STATE OF DELAWARE  
EXECUTIVE DEPARTMENT  
OFFICE OF MANAGEMENT AND BUDGET  
STATE PLANNING COORDINATION

RE: PLUS review – PLUS 2005-12-09; Westtown Marketplace – Phase 3

According to the information received, you are seeking site plan approval for 270,000 sq. ft. of commercial space on 30 acres.

# Westown/Westown Marketplace Phase III

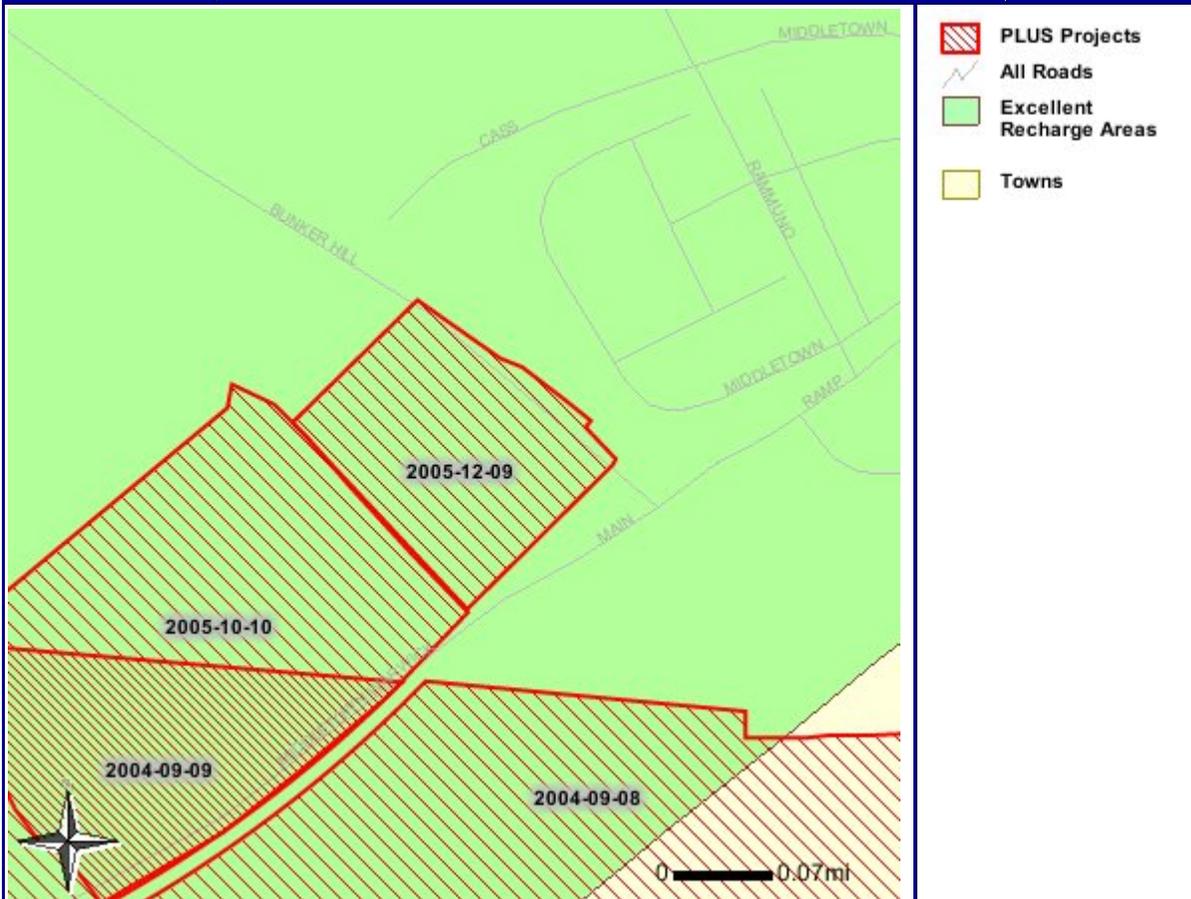
The DNREC Water Supply Section has determined that the entire parcel falls within an area of excellent groundwater recharge (see the following map and attached map).

The proposed development would change the total impervious cover from approximately 0% to approximately 75%. These numbers were provided by the developer on the PLUS application. This number far exceeds the values set forth by New Castle County. The parcel is located in the Town of Middletown. Currently, the Town of Middletown does not have a Source Water Protection Component to their comprehensive plan.

DNREC Water Supply Section recommends that that portion of the new development within the excellent recharge area not exceed 20% impervious cover. Further, some allowance for augmenting ground-water recharge should be considered if the impervious cover exceeds 20% but is less than 50% of that portion of the parcel within this area. The purpose of an impervious cover threshold is to minimize loss of recharge (and associated increases in storm water) and protect the quality and quantity of ground water and surface water supplies.
